Subject: Oconee Nuclear Station
Docket Nos. 50-269, 50-270, 50-287

Duke Power Company
Oconee Nuclear Station - Unit 1
Request For Relief from Inservice
Inspection Requirements (Hydrostatic)

- (a) Name and Number: Emergency Feedwater Pump Turbine Oil Cooler
Pump Suction - Weld No. 1FA
- (b) Function: Tie-in weld to existing 78" Condenser Circulating
Water Line
- (c) ASME Section XI Code Class: 3
- (d) Valve Category: N/A

sheet 7 of

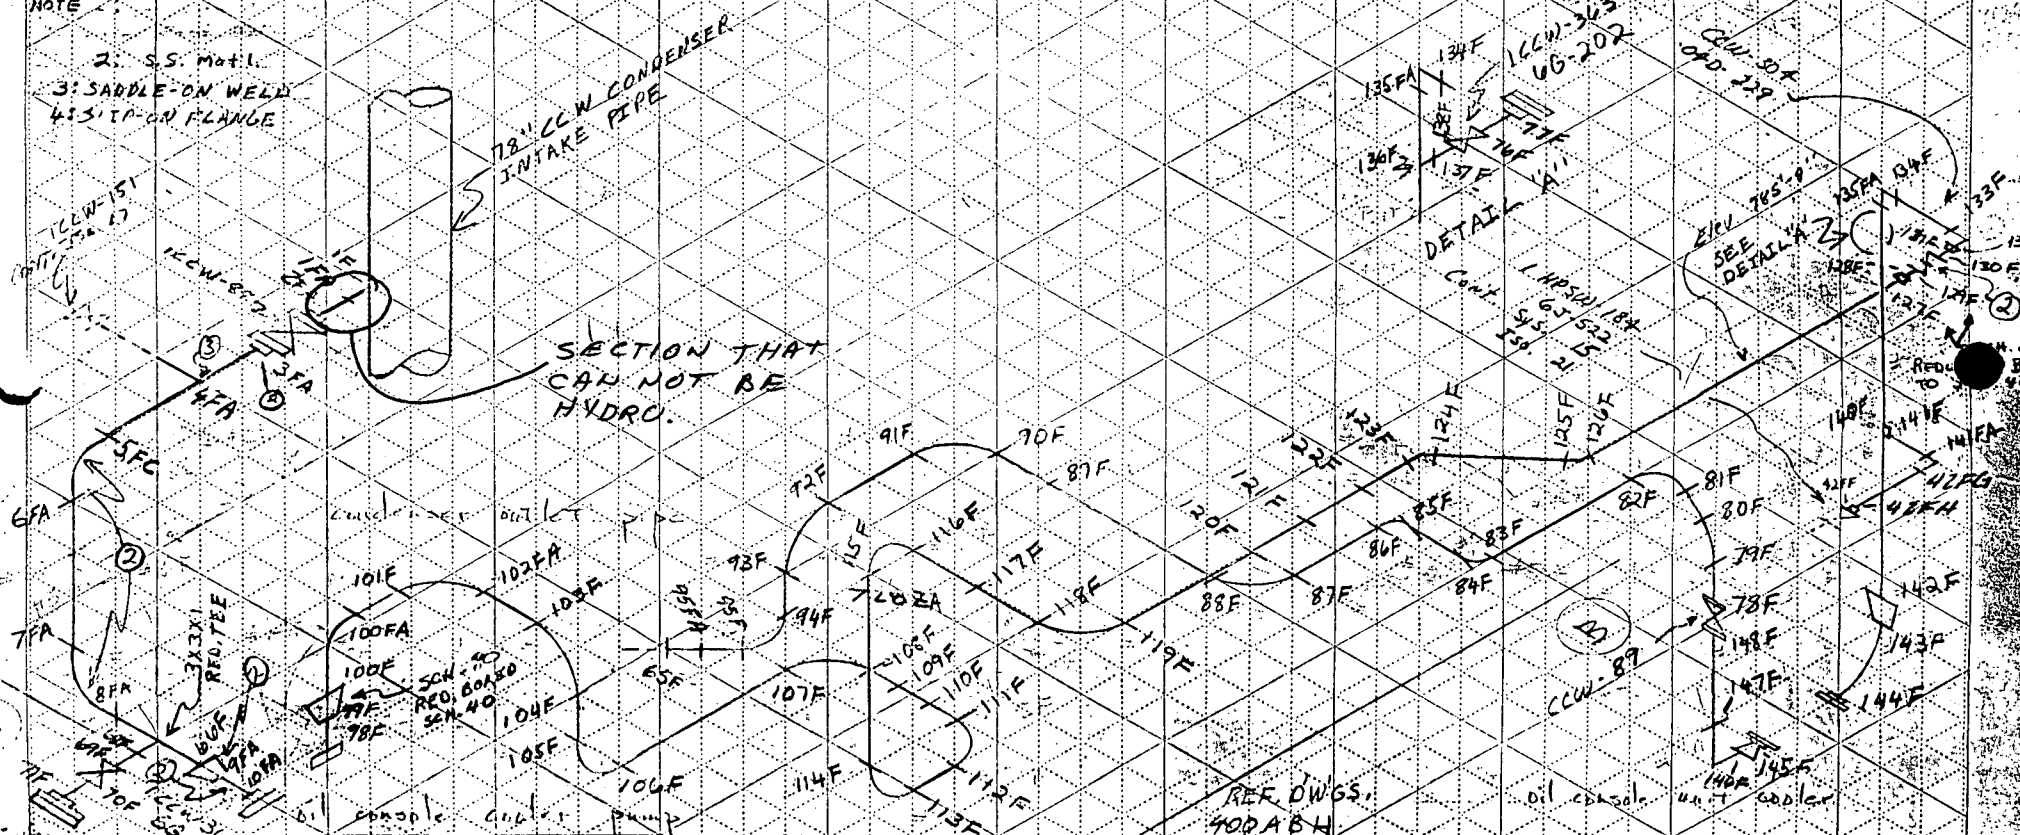
Weld 1FA (shown on attached sketch) cannot be isolated from the
condenser circulating water system. Performance of the required
hydrostatic test would require pressurizing the system to the
condenser circulating water pumps.

The weld will be penetrant tested and inservice leak tested.
